ACCESSION NBR: 8201260202 DOC. DATE: 82/01/11 NOTARIZED: NO DOCKET #.
 FACIL: 50-397. WPPSS Nuclear Project, Unit 2, Washington Public Power 05000397.
 AUTH. NAME: AUTHOR AFFILIATION
 BOUCHEY, G. D. Washington Public Power Supply System
 RECIP. NAME: RECIPIENT AFFILIATION
 SCHWENCER, A. Licensing Branch 2.

SUBJECT: Forwards responses to remaining Reactor Sys Branch Questions
 211.129, 211.031, 211.148 & 211.209. Revised FSAR pages re
 ODDYN code will be incorporated into Amend 23..

Subject: NUCLEAR PROJECT NO. 2
RESPONSES TO REACTOR SYSTEMS BRANCH QUESTIONS
AND ODYN ANALYSIS WNP-2 FSAR REWRITE

FIGURE 5.2-5
TIME RESPONSE OF PRESSURE VESSEL FOR
PRESSURIZATION EVENTS

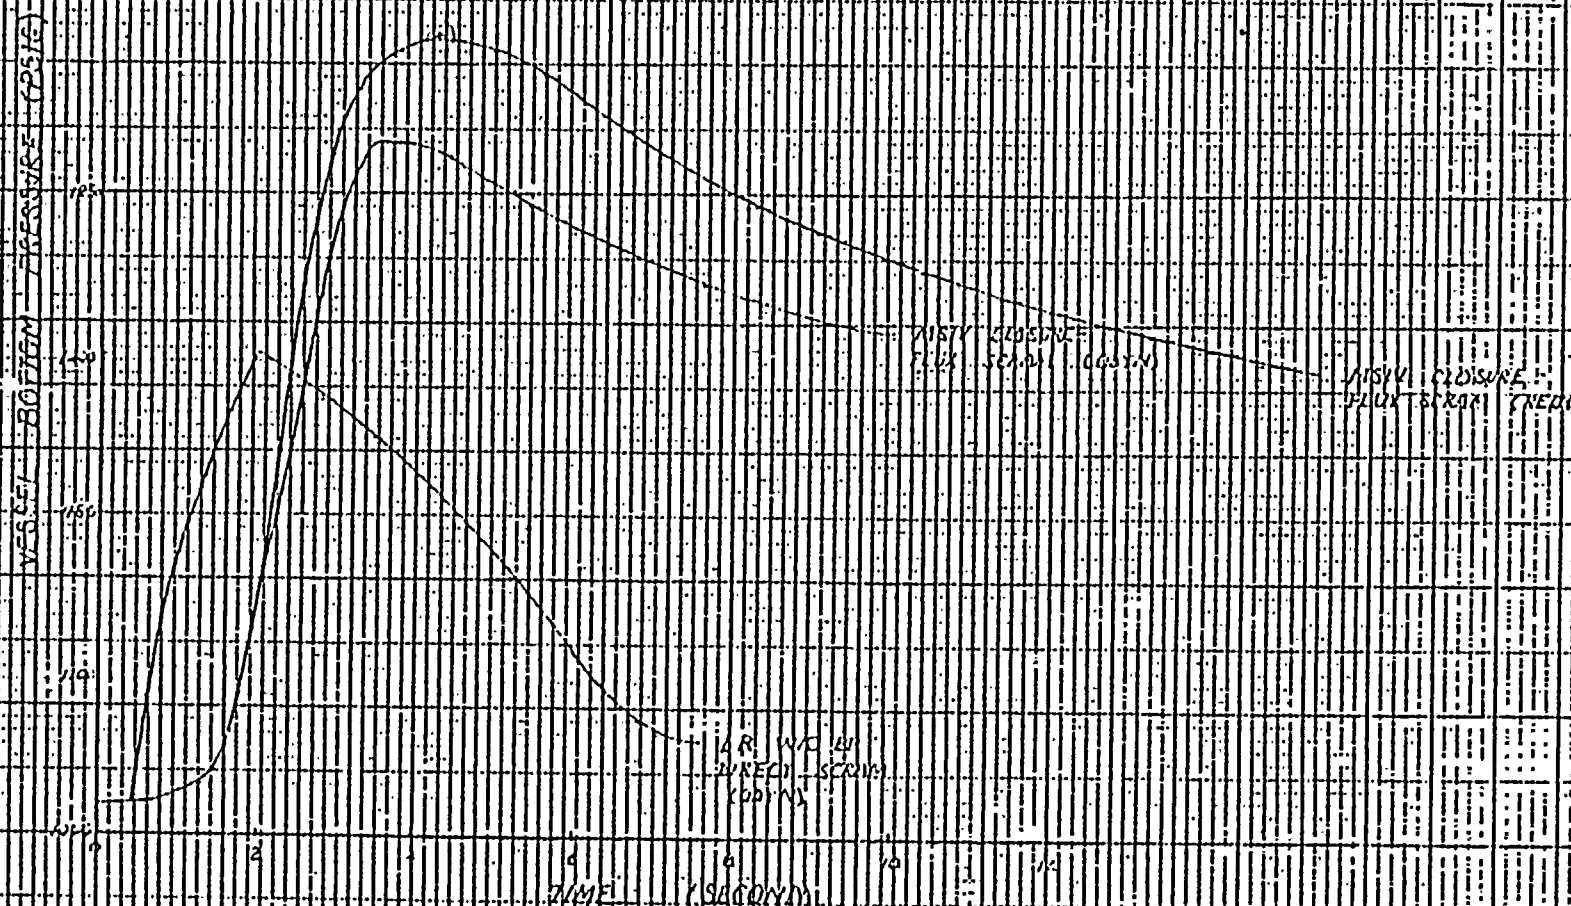
REPLACE WITH NEW FIGURE

As seen in the time response plot of the reactor vessel bottom pressure in Figure 5.2-5, more pressure safety margin is predicted by ^{had} the OBYN model, which is more ~~extensive~~, than by the REDY model.

FIG. 15.0-3 Minimum Operating CPR Limit vs. Scram Speed

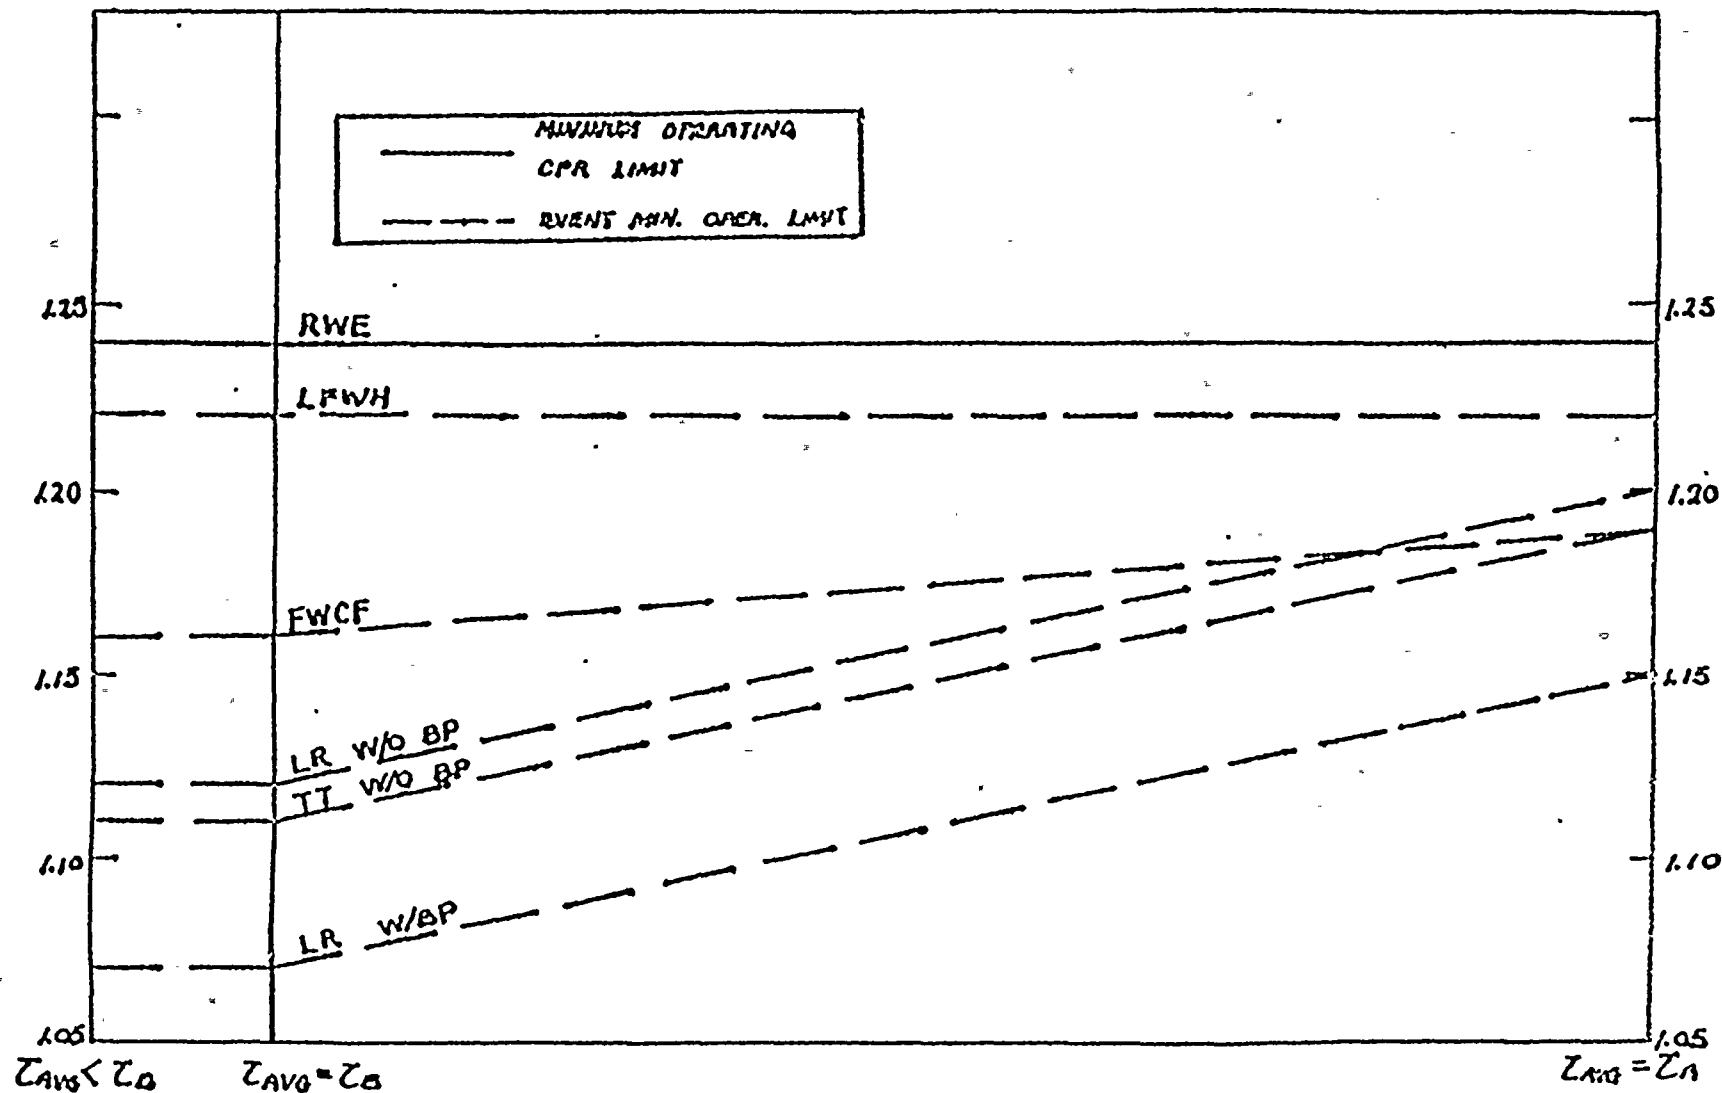
--- Revised portion of scram speed used in ODDYN analysis

The operating limit MCPR is the maximum value of the event MCPRs calculated from the transient analysis. The maximum calculated transient MCPR is depicted by the solid line in Figure 15.0-3. Maintaining the CPR operating limit at or above this operating limit assures that the safety limit CPR of 1.06 is never violated.

FIG. 15.1-3

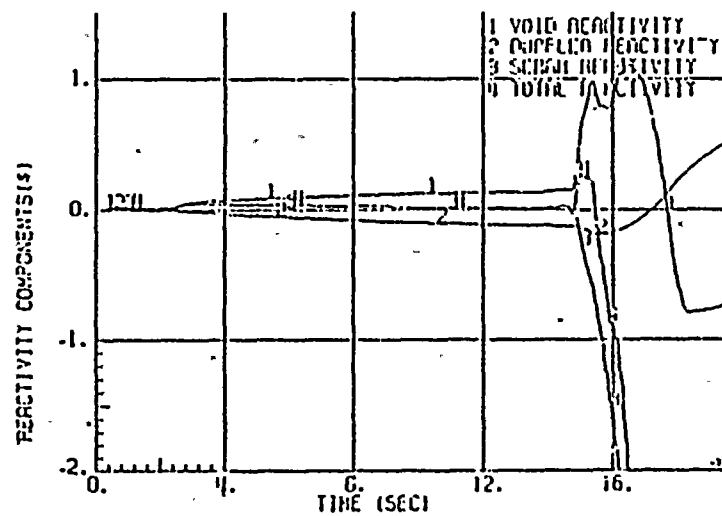
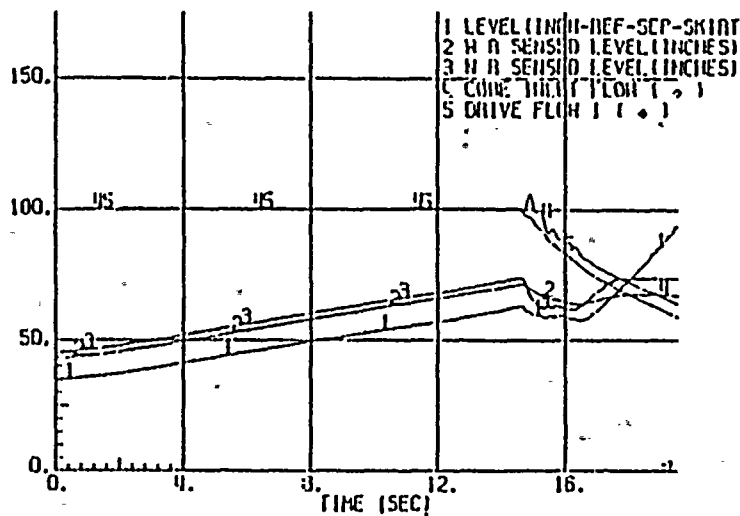
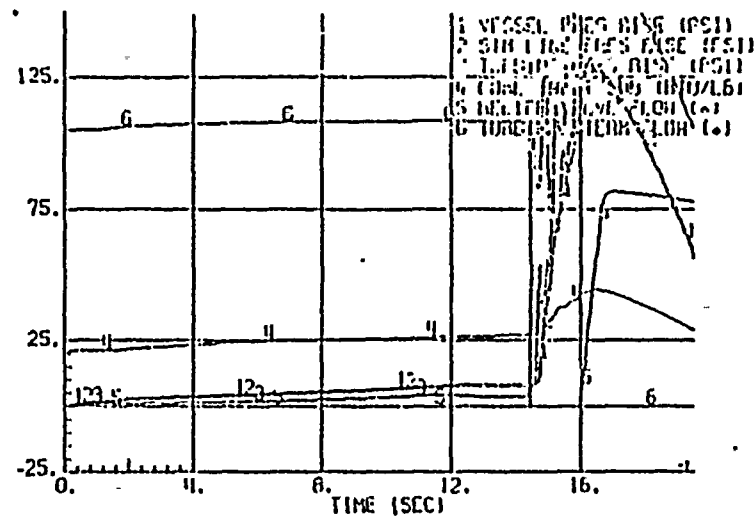
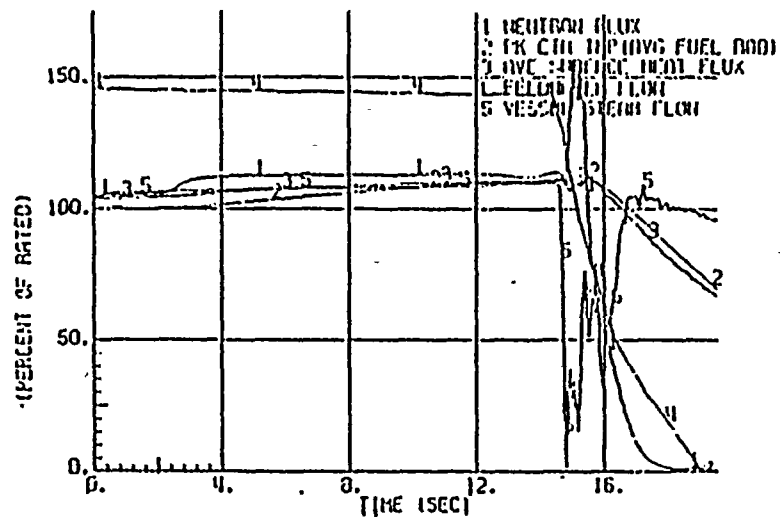
REPLACE WITH NEW FIGURE

14.4 The simulated feedwater controller transient at 105% NBR steam flow is shown in Figure 15.1-3. The high water level turbine trip and feedwater pump trip are initiated at approximately 10.2 sec. Scram occurs simultaneously from stop valve closure, and limits the neutron flux peak and fuel thermal transient so that no fuel damage occurs.

FIG. 15.2-1
KKECHMOILALOG--
GENERATOR LOAD REJECTION, WITH BYPASS ON, RPT-ON.

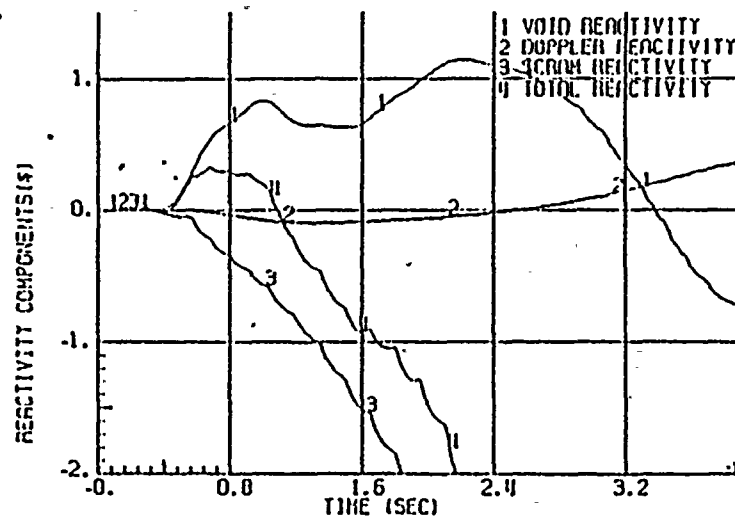
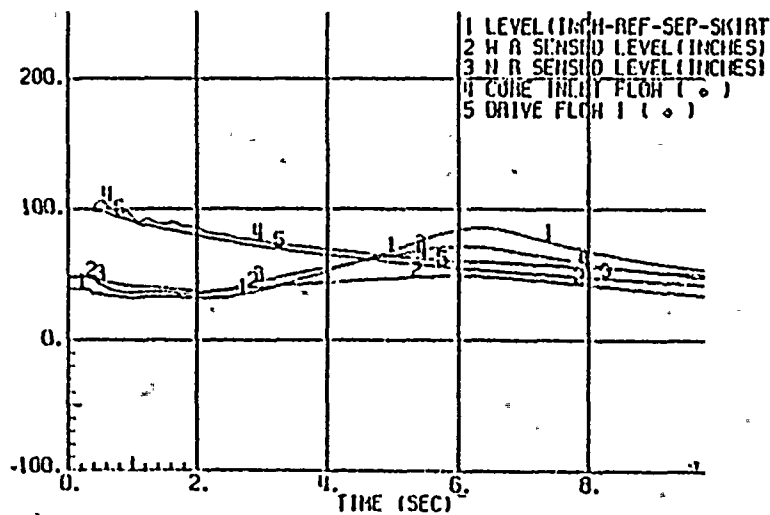
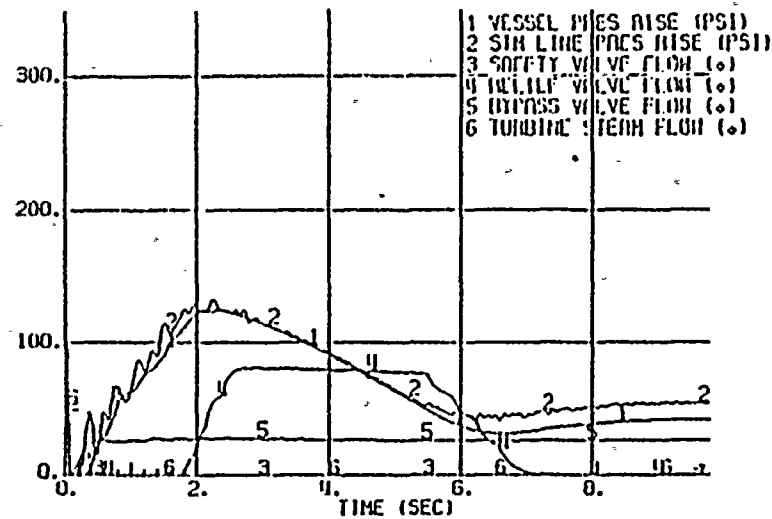
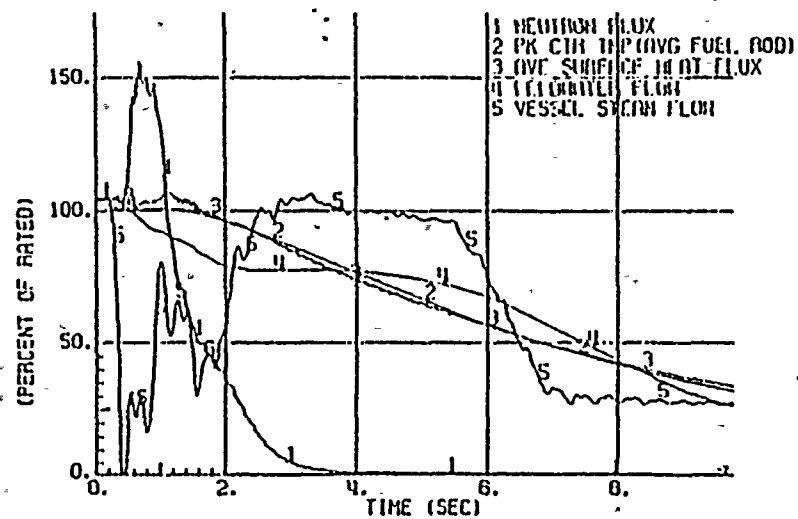
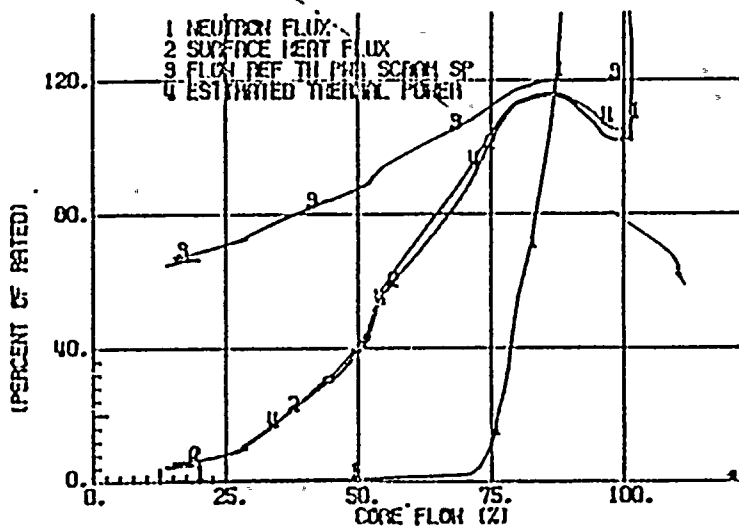
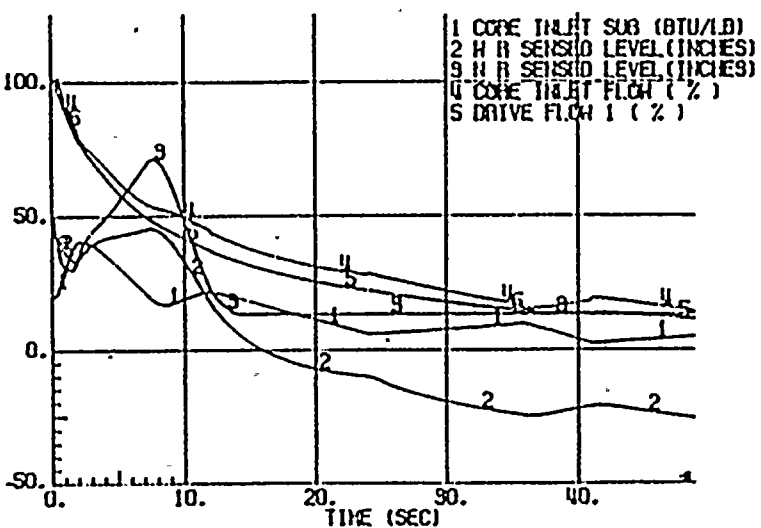
REPLACE WITH NEW FIGURE 13

Figure 15.2-1 shows the results of the generator trip from rated power. Peak neutron flux rises ~~165%~~ above NB rated conditions. ^{156.8%}

FIG. 15.2-2
KKICIMOLR105
GENERATOR LOAD REJECTION, HITOUT BYPASS, RPT-ON

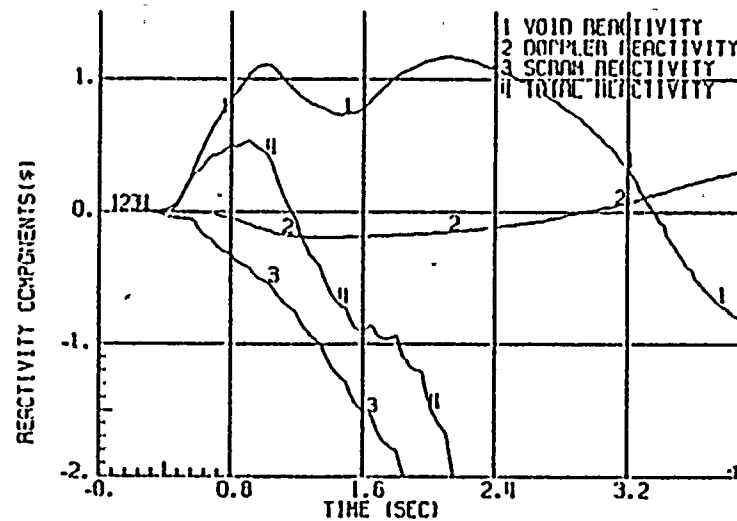
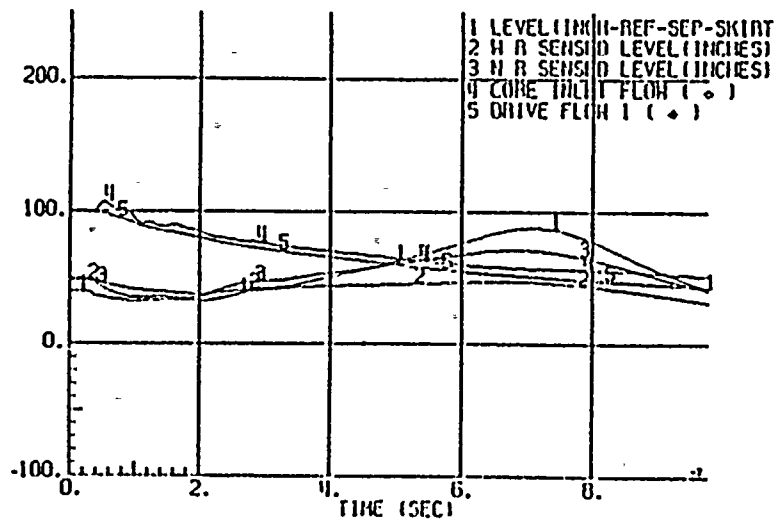
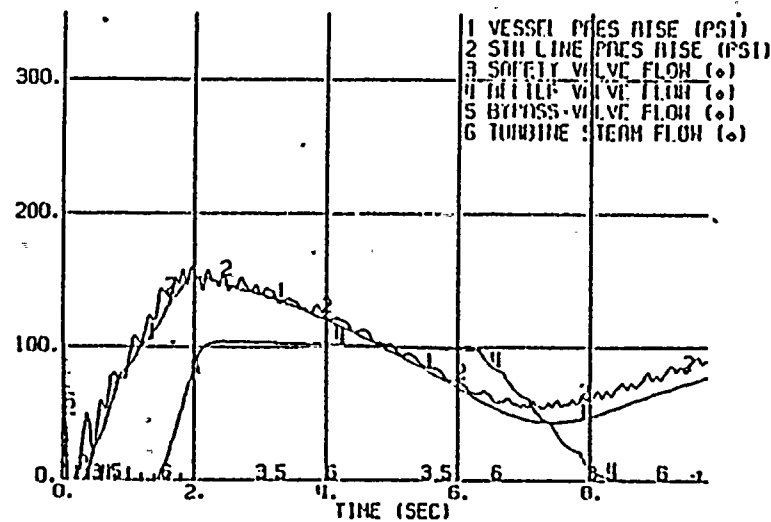
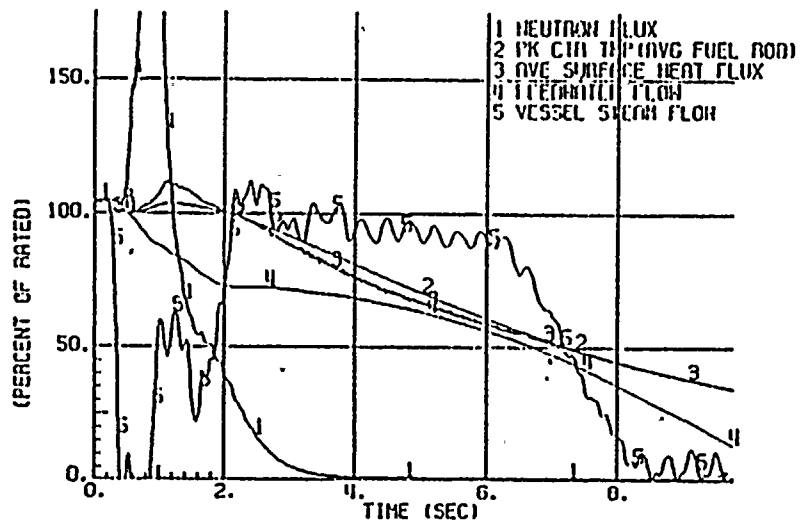
REPLACE WITH NEW FIGURE

Figure 15.2-2 shows that, for the ^{236.4%} case of Bypass failure, peak neutron flux reaches about ~~24.4%~~ of rated, average surface heat flux reaches ~~110.5%~~ of its initial value. ^{107.8%} Since this event is classified as an infrequent incident, it is not limited by the GZTB criteria and the MCPR limit is permitted to fall below the safety limit for the incidents of moderate frequency. MCPR reaches 1.05 for this event.

FIG. 15.2-4

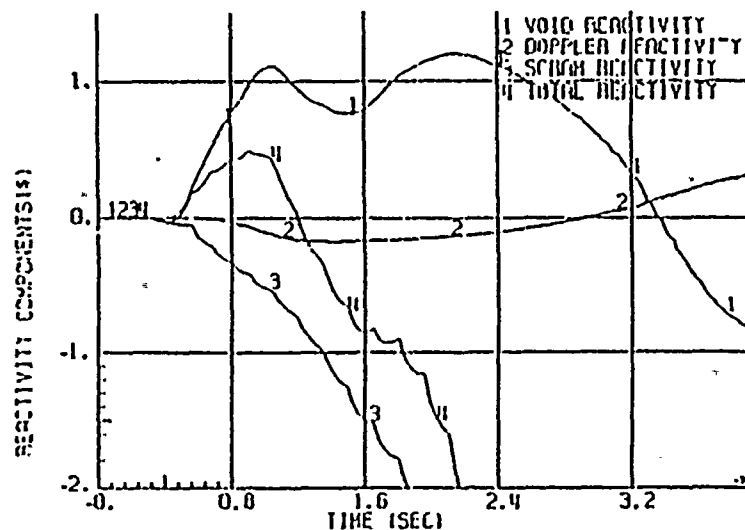
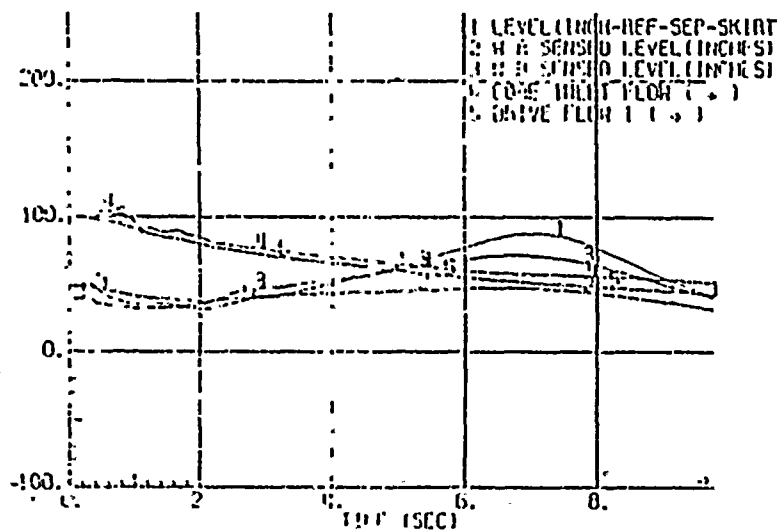
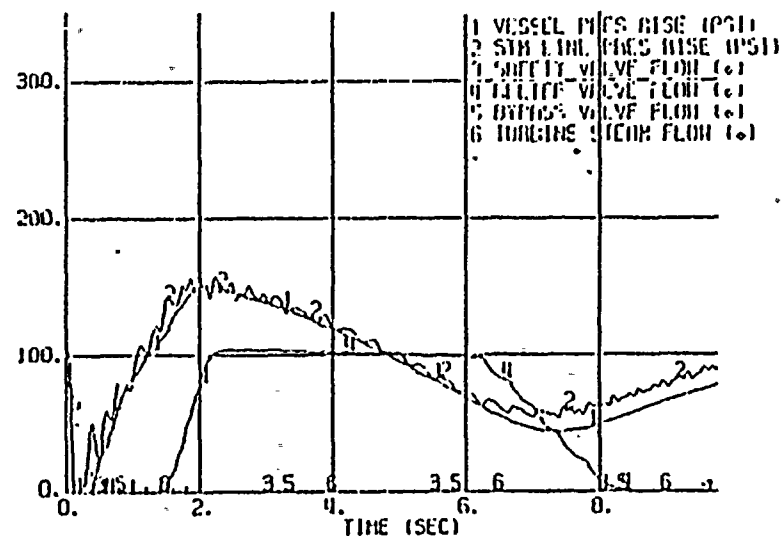
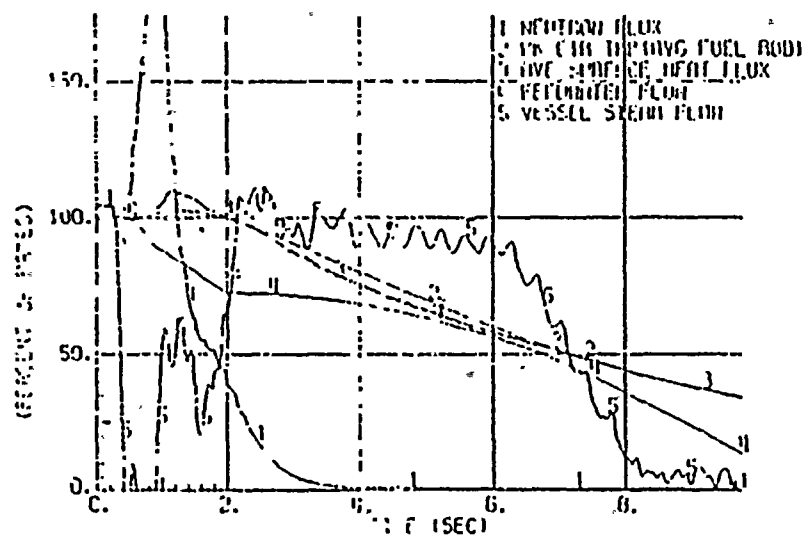
REPLACE WITH NEW FIGURE
15.2-27
